HISTORIC AND DESIGN REVIEW COMMISSION

HDRC CASE NO: 2020-435
COMMON NAME: 1111 & 1115 N Palmetto
LEGAL DESCRIPTION: NCB 1302 BLK 3 LOT E 144.84 FT OF 10
ZONING: R-5, H
CITY COUNCIL DIST.: 2
DISTRICT: Dignowity Hill Historic District
APPLICANT: James Benfield/Benfield Real Estate
OWNER: James Benfield/Benfield Real Estate
TYPE OF WORK: Construction of two, 2-story residential structures
APPLICATION RECEIVED: September 28, 2020
60-DAY REVIEW: Not applicable due to City Council Emergency Orders
CASE MANAGER: Edward Hall

REQUEST:

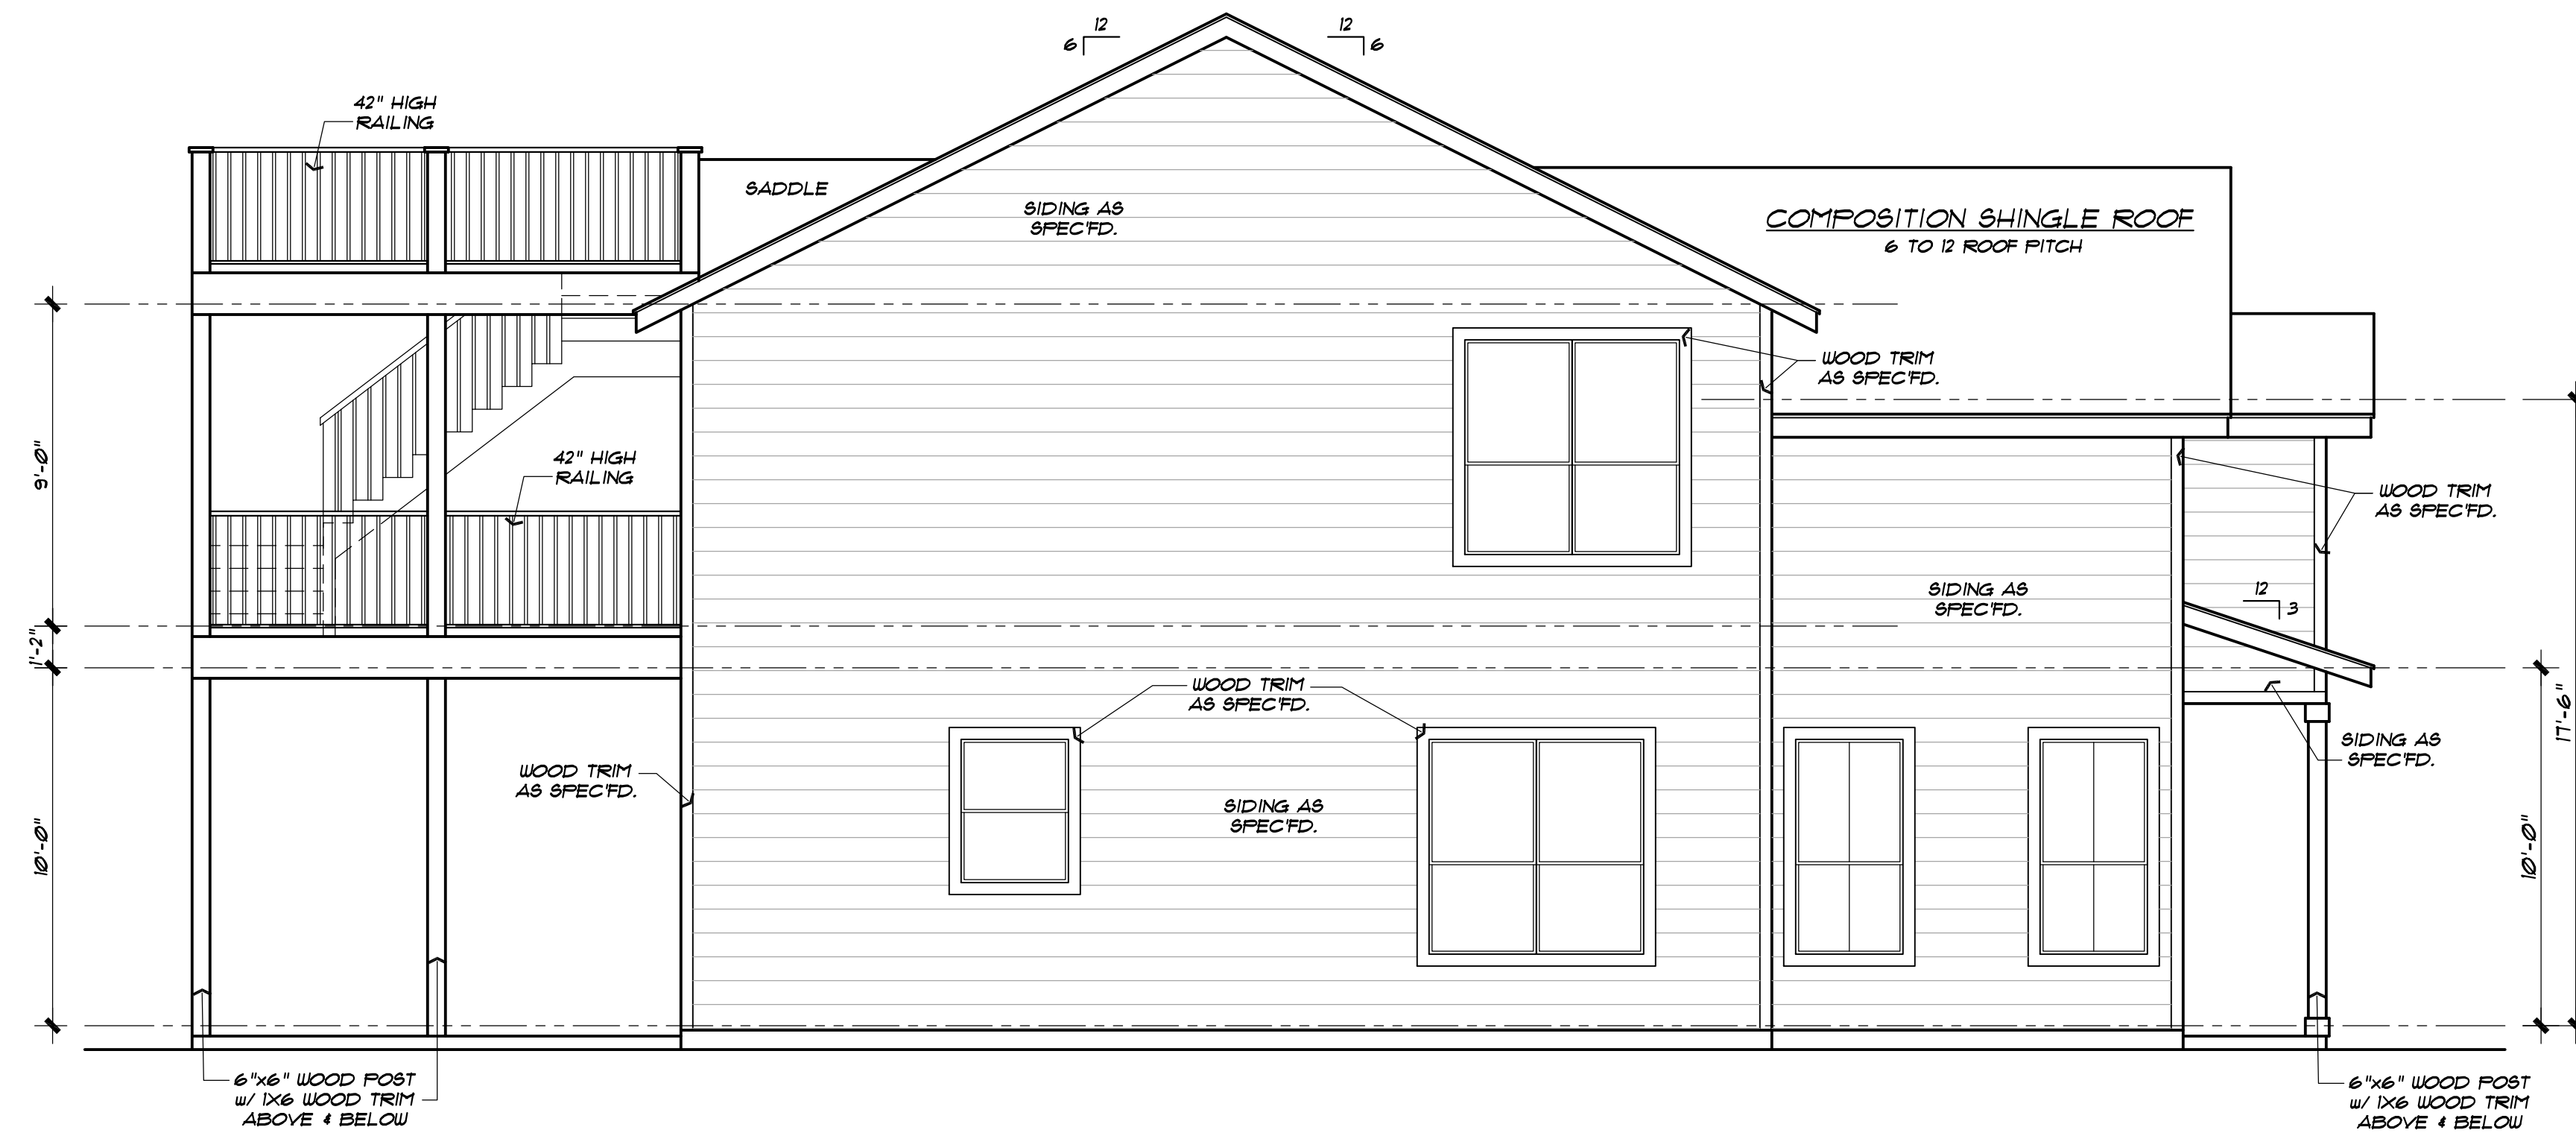
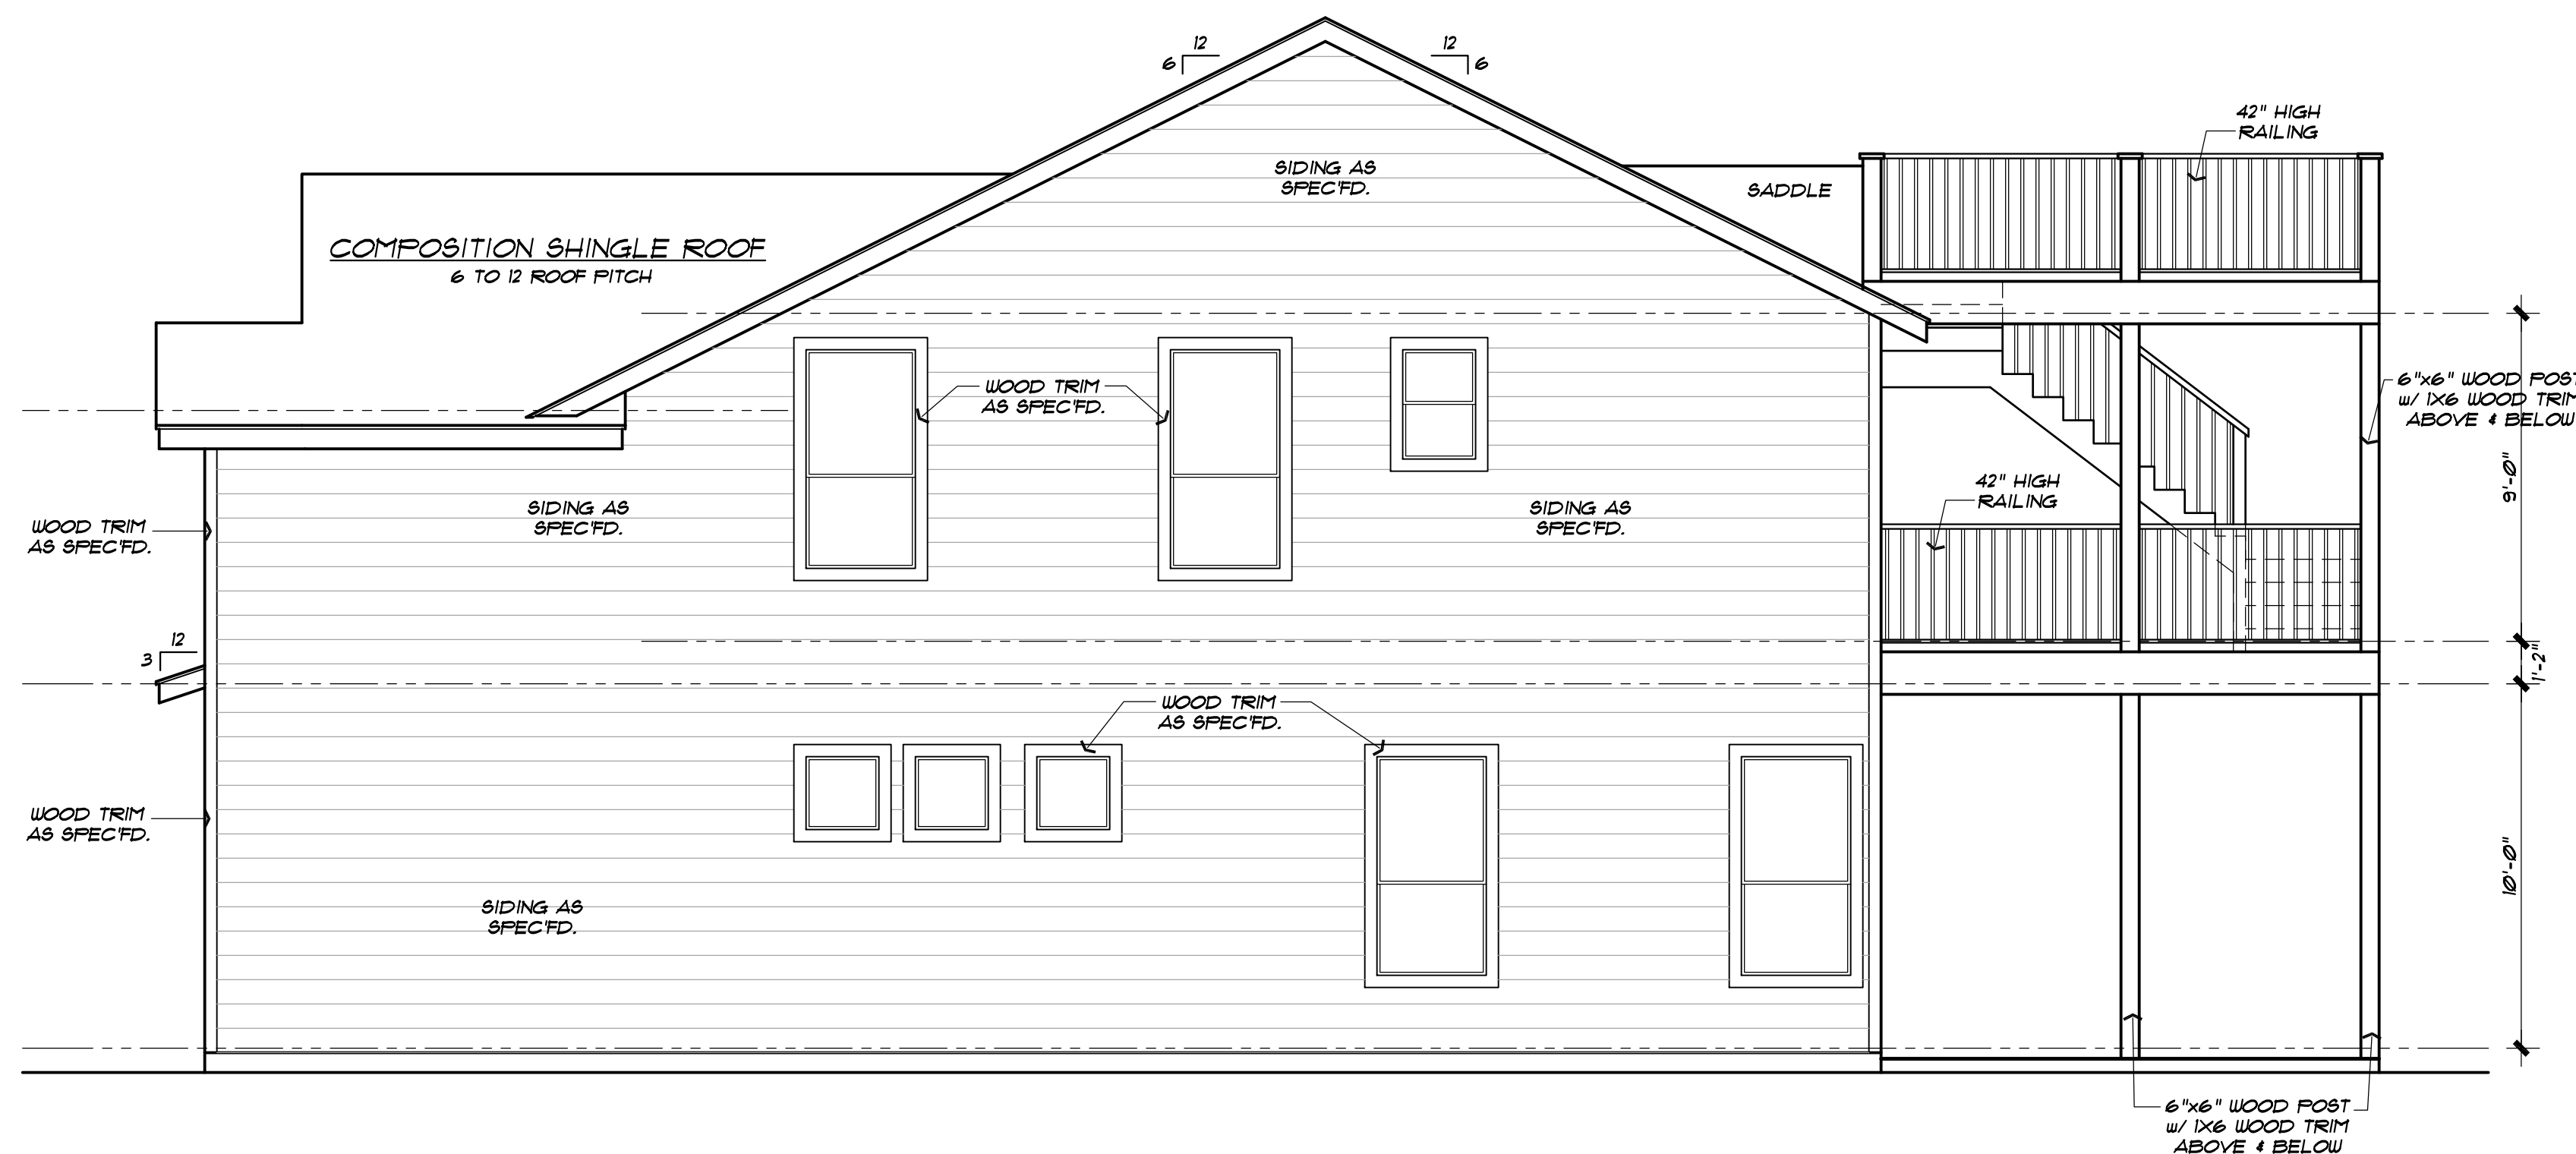
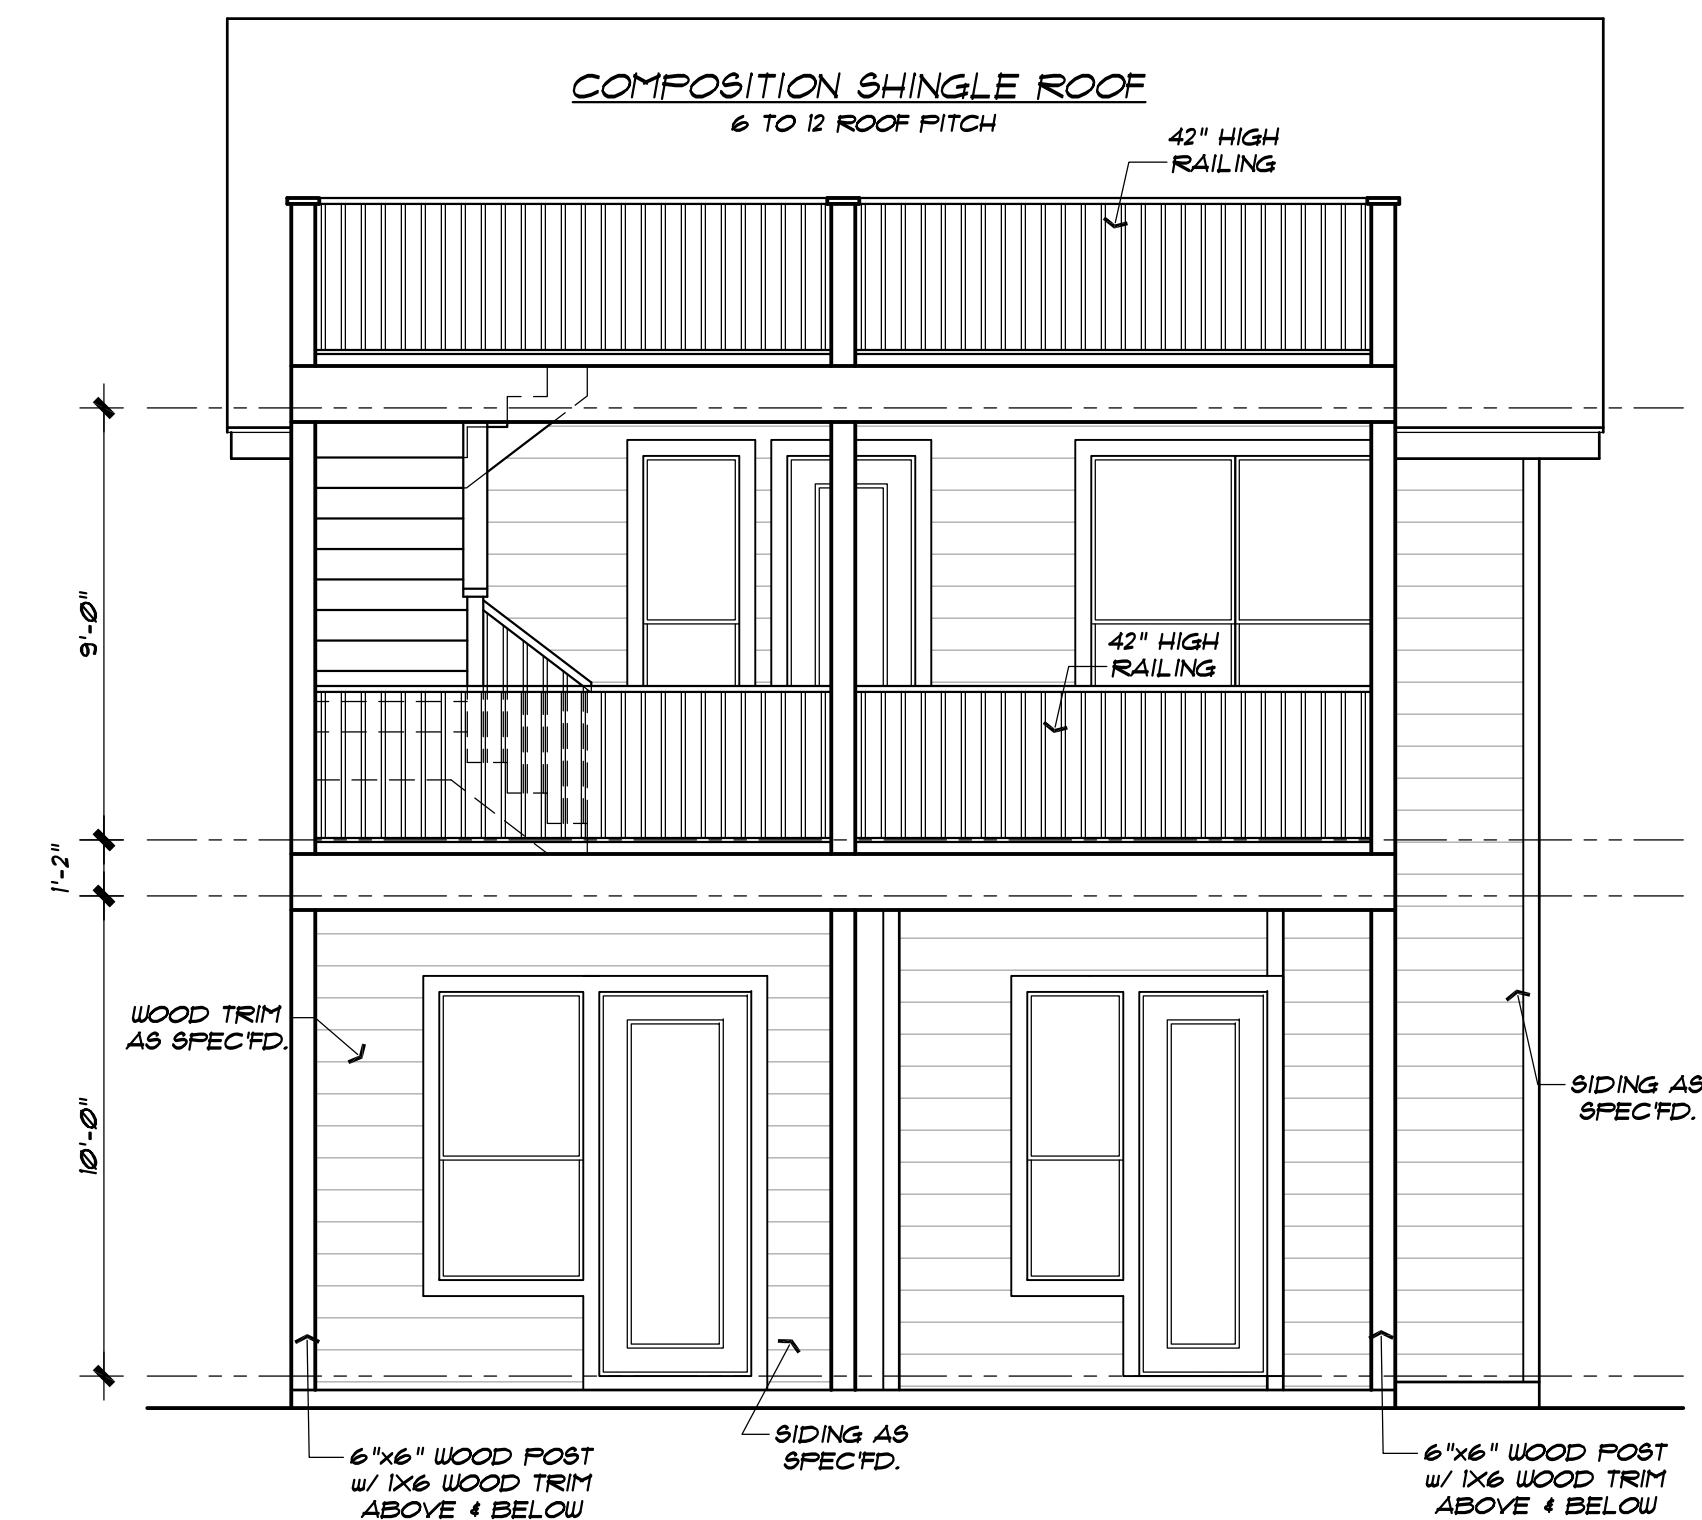
- 1b. **SCALE & MASS** – Per the Guidelines for New Construction 2.A.i., a height and massing similar to historic structures in the vicinity of the proposed new construction should be used. In residential districts, the height and scale of new construction should not exceed that of the majority of historic buildings by more than one-story. As noted in finding b, this block on N Palmetto features all one story structures. The applicant has proposed an overall height of approximately twenty-seven (27) feet. Because of the change in scale, staff finds that it would

- 1d. FOUNDATION & FLOOR HEIGHTS – Per the Guidelines for New Construction 2.A.iii., applicants should align foundation and floor-to-floor heights within one foot of floor-to-floor heights on adjacent historic structures. The applicant has not specified the exact foundation height. The applicant is responsible for complying with the Guidelines regarding foundation heights.

- 1e. ROOF FORMS – The applicant has proposed roof forms that include front and side facing gabled roofs. Staff finds the proposed roof forms to be appropriate and consistent with the Guidelines.

- 1f. WINDOW & DOOR OPENINGS – Per the Guidelines for New Construction 2.C.i., window and door openings with similar proportions of wall to window space as typical with nearby historic facades should be incorporated into new construction. Staff finds that all ganged and grouped windows should be separated by a mullion of at least six (6) inches in width. Additionally, staff finds that windows should be added to both the north and south facades near the front of both structures and that non-traditionally sized window openings should be eliminated, such as fixed square windows.

- 1g. PORCH MASSING – The applicant has proposed porch massing that is integral to the massing of both structures. Generally, staff finds the proposed porch massing to be appropriate; however, staff finds that the proposed porch depth should be increased to at least five (5) feet.

- 1l. ARCHITECTURAL DETAILS – As noted in finding 1f, staff finds that all ganged and grouped windows should be separated by a mullion of at least six (6) inches in width. Additionally, staff finds that windows should be added to both the north and south facades near the front of both structures and that non-traditionally sized window openings should be eliminated, such as fixed square windows. Additionally, staff finds that porches should be increased in depth to at least five (5) feet, as noted in finding 1g.

- i. That the applicant incorporate several design strategies to mitigate the visual impact of the additional height including utilizing a half story or an additional increase in front yard setback. as noted in findings 1b and 2b.

- ii. That foundation heights that are consistent with the Guidelines be utilized as noted in findings 1d and 2d.
- iii. That all ganged and grouped windows be separated by a mullion of at least six (6) inches in width. Additionally, staff recommends that windows should be added to both the north and south facades near the front of both structures and that non-traditionally sized window openings should be eliminated, such as fixed square windows, as noted in findings 1f and 2f.

- iv. That the applicant increase the porch depth to at least five (5) feet as noted in findings 1g and 2g.
- v. That the applicant install windows that meet staff's standards specifications as noted in findings 1j and 2j.
